Your ref: Docket No. 52-006
Our ref: DCP/NRC1628

SUBJECT: Transmittal of Responses to AP1000 DSER Open Items

Draft Safety Evaluation Report Open Item Response

Figure 24 - Bounding Analysis Curve – ADS Stage 4 – 14" (610 °F)

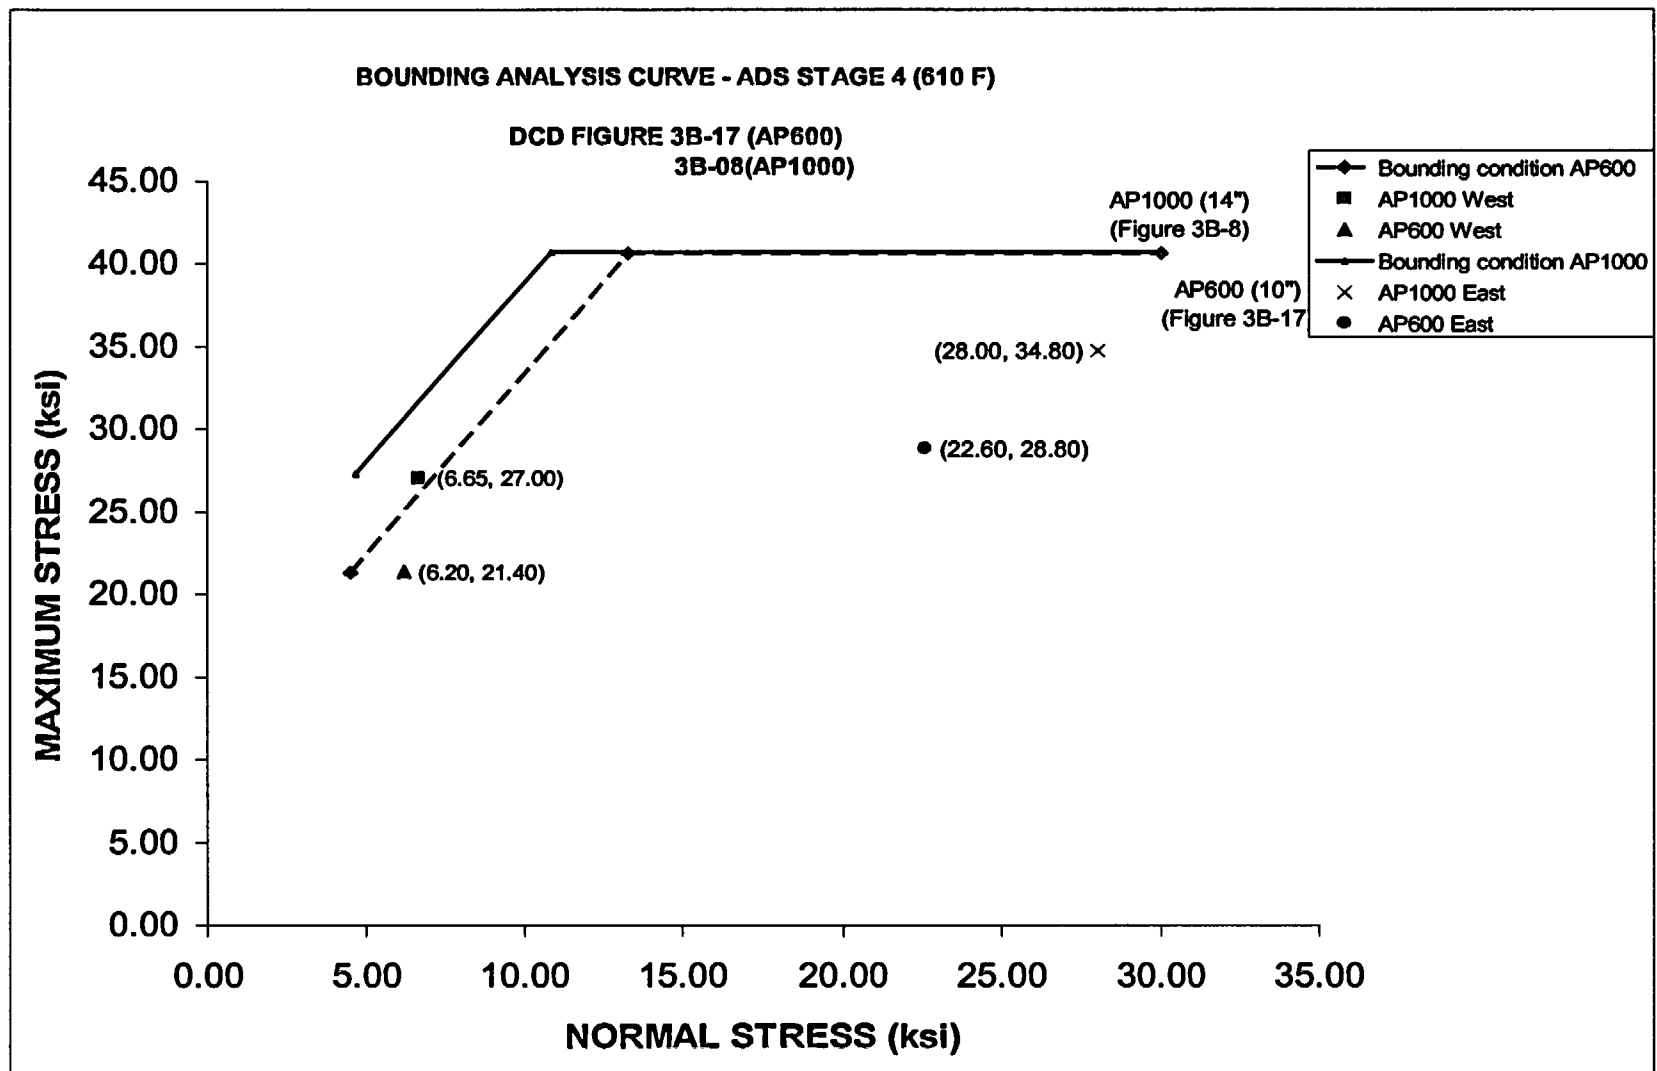
The ADS Stage 4 pipe diameter is larger than the AP600 (10"). The seismic multiplication factor is 1.74. This includes the affect of the higher elevation of the steam generator upper lateral support. The maximum stress is 32.7 ksi before adjustment for pipe diameter and 27.0 ksi after adjustment. The adjusted stress is less than the corresponding BAC stress of 31.6 ksi. Figure 24

Figure 3.8.4.3-1- 1 – Temperature Profiles In Structural Module Wall During Initial Part of Thermal Transients

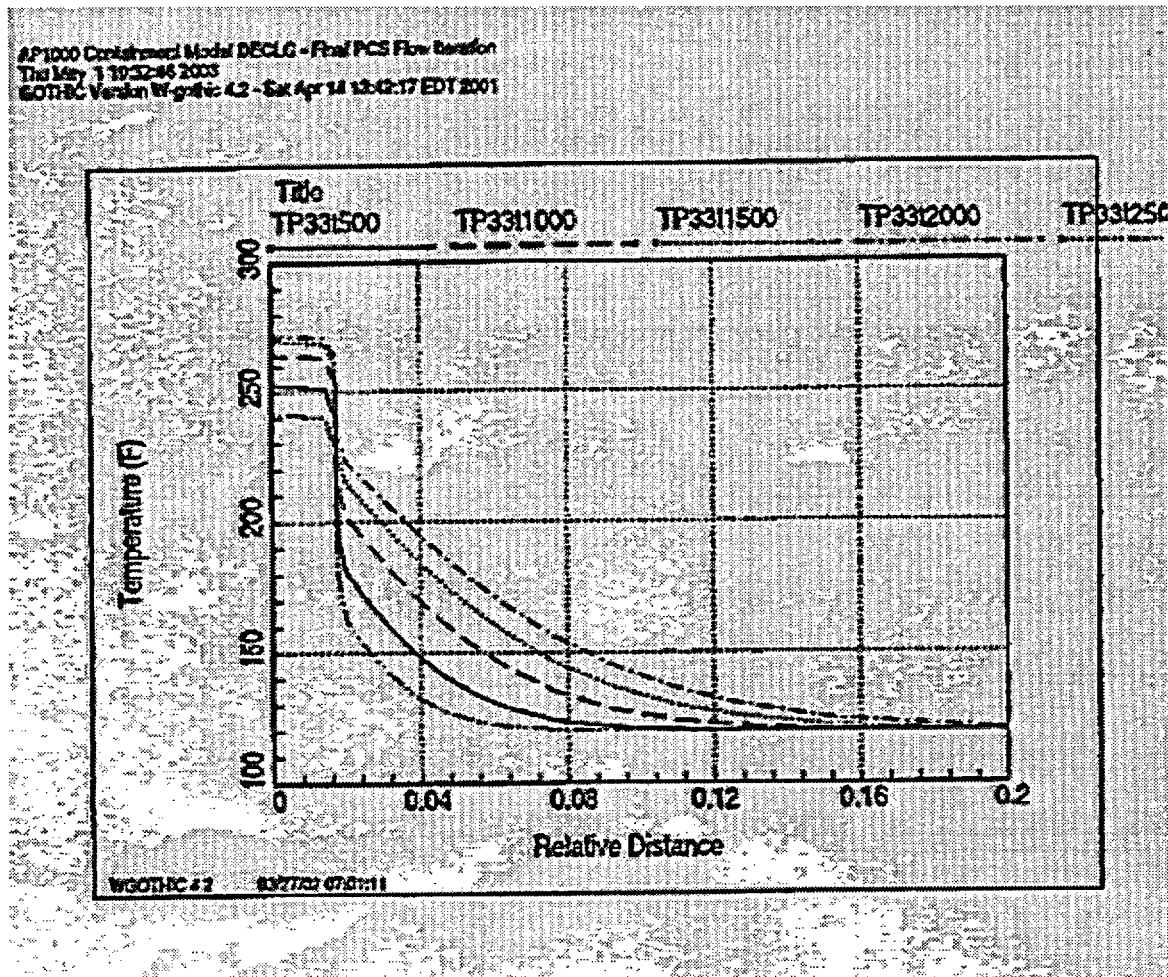
The applicant referenced DCD Tier 2 Figure 3D.5-9 in its response to RAI 220.015; however, it does not appear to have considered the effect of rapid increase in compartment temperature. Based on its review of the selected calculations, the staff could not reach a conclusion that the applicant has adequately addressed the effects of thermal transients on concrete filled steel modules. The analysis approach for the thermal transient inside the IRWST is discussed in Subsection 3.8.3.3 of this report, and has been found to be acceptable. However, for subcompartment locations inside containment (other than the IRWST) and locations outside containment, rapid heat-up of the steel plate of the structural wall modules must be considered in the analysis and design of the structural wall module. The concern is that for a rapid temperature transient, the mismatch in thermal conductivity between the steel faceplate and the concrete could impose significant thermal stresses on the faceplate, studs, and concrete core. This could potentially result in degradation of the faceplate/concrete bond and invalidate the assumption of composite behavior. The applicant needs to evaluate the thermal transients that can occur in the various subcompartments, and demonstrate that no unacceptable degradation would result from differential thermal expansion of the steel and concrete throughout the entire transient. This is Open Item 3.8.4.3-1.

Structural modules are subjected to a rapid temperature transient in the event of a loss of coolant accident (LOCA) or a main steam line break (MSLB). The steel plate of the structural modules heats up most rapidly in the LOCA event. DCD Figure 6.2.1.1-6 shows the containment temperature response for the double ended cold leg break. Figure 3.8.4.3-1-1

Figure 3.8.4.3-1- 2 – Unlaxial Strip Plate

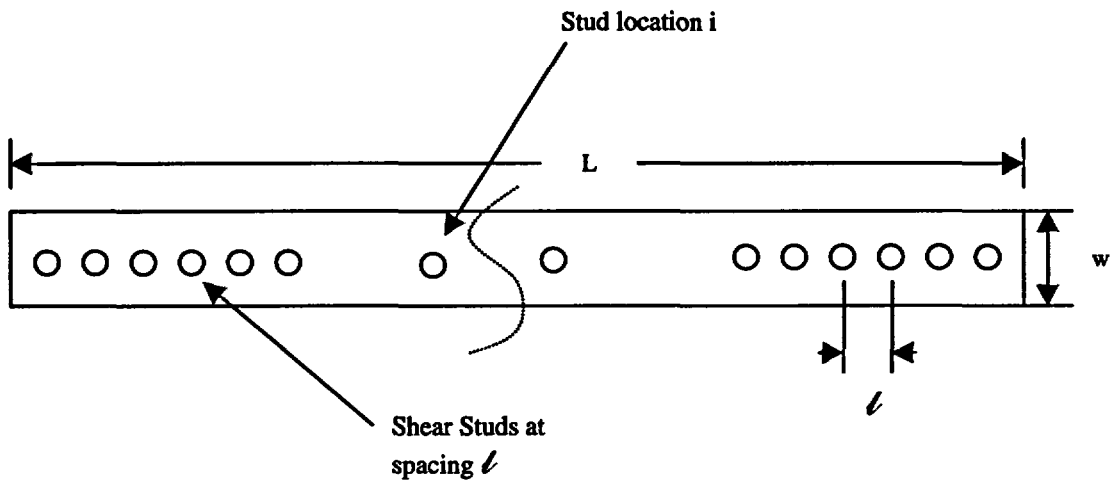
The uniaxial strip plate shown in Figure 3.8.4.3-1-2 represents a single row of shear studs in either the horizontal or vertical direction. A typical wall is considered with a length or height of 30'. Similar uniaxial models were evaluated for the AP600. The AP600 evaluation used a continuum representation of the shear studs to evaluate the interface between the steel plate, studs and concrete. The AP1000 evaluation uses a discrete representation of each shear stud.

Figure 3.8.4.3-1- 3 – Thermal Displacement Mathematical Formulations

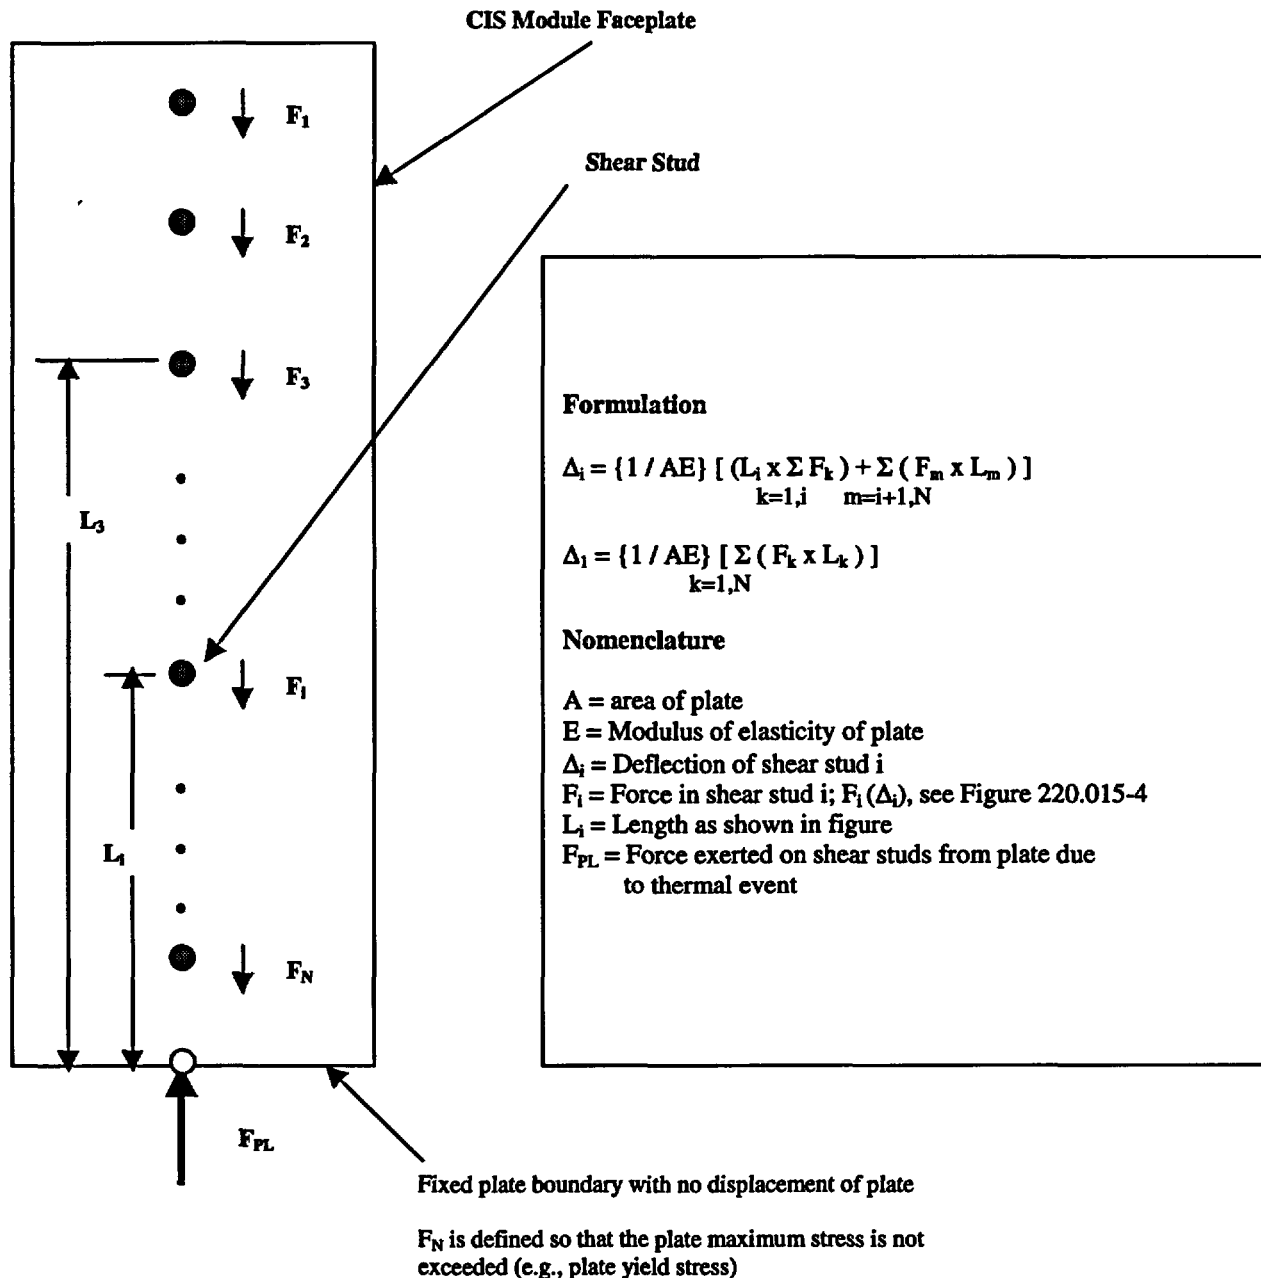
The formulation for the AP1000 thermal evaluation is given in Figure 3.8.4.3-1-3. The load in the shear stud is determined from a non-linear shear stud load-deflection curve based on Ollgaard and Slutter 1971 tests (Reference 3.8.4.3-1-1) as shown in Figure 3.8.4.3-1-4. The shear stud can transmit a peak load (24 kips) to the concrete even if there is localized deformation and crushing of the concrete in the vicinity of the shear stud. The test results show continued load capacity at deflections above 0.10 inches. This deflection of 0.1" is chosen as a representative limit for the evaluation. The force in a shear stud (F_i) and its displacement is a function of the axial stiffness of the plate (AE/L_k), the net force in the plate at stud location i , and the movement of the plate caused by the forces in the shear studs below the stud at location i .

Figure 3.8.4.3-1- 5 – Thermal Growth Shear Stud Loads

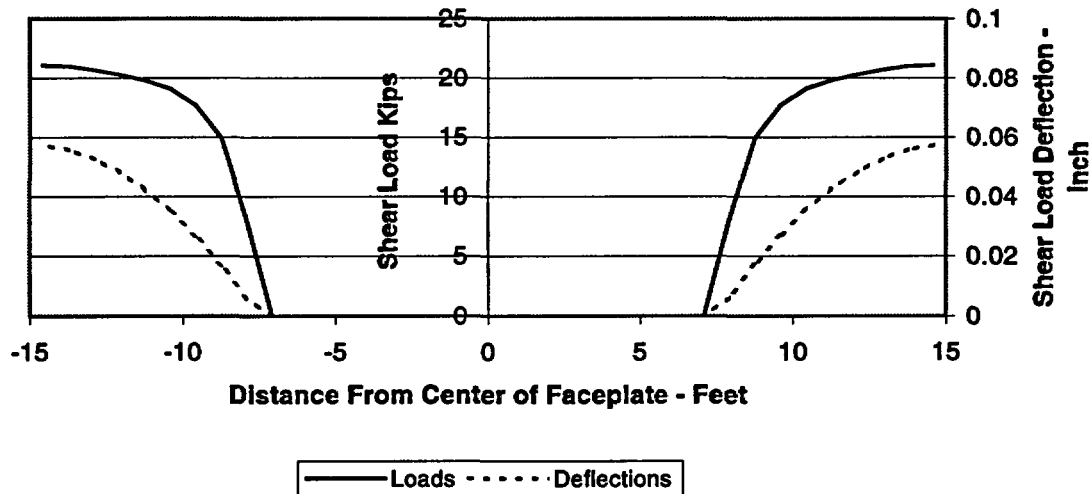
The shear stud load and deflections calculated using the uniaxial model for the carbon steel plate are shown in Figure 3.8.4.3-1-5. Figure 3.8.4.3-1-6 shows the stress in the faceplate when the surface plate is heated to 240°F during the initial part of the thermal transient. The maximum stress reaches yield in the central region of the plate. The maximum deflection in the shear stud (near the edge of the plate) is 0.057" (0.075" for the stainless steel plate) and is less

Figure 3.8.4.5-2-1
Axial Load-Moment Interaction Diagram

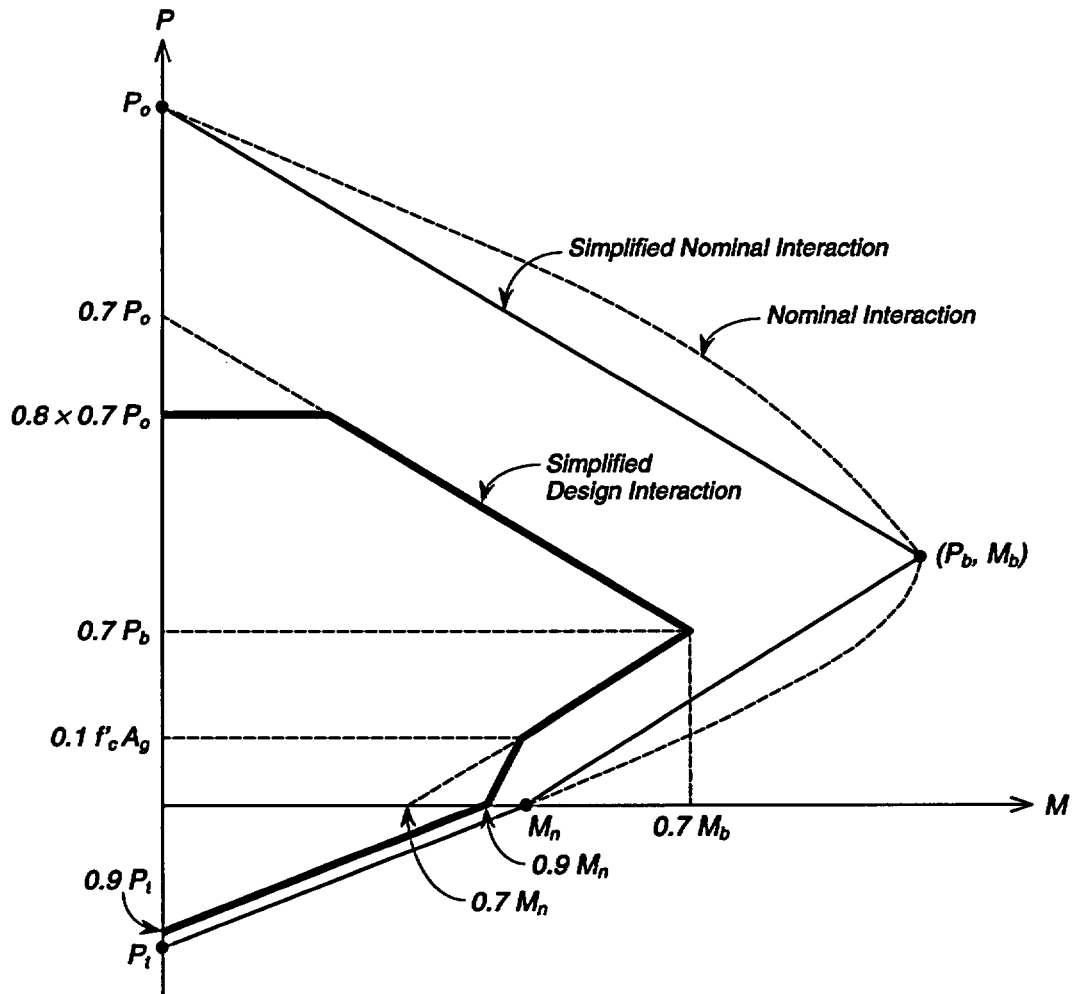
Figure 3.8.4.5-2-1 shows a typical interaction diagram defining the strength of a concrete section under combined axial force (P) and bending moment (M). It shows the nominal strength interaction as well as a simplified nominal interaction based on straight lines connecting the following key points:
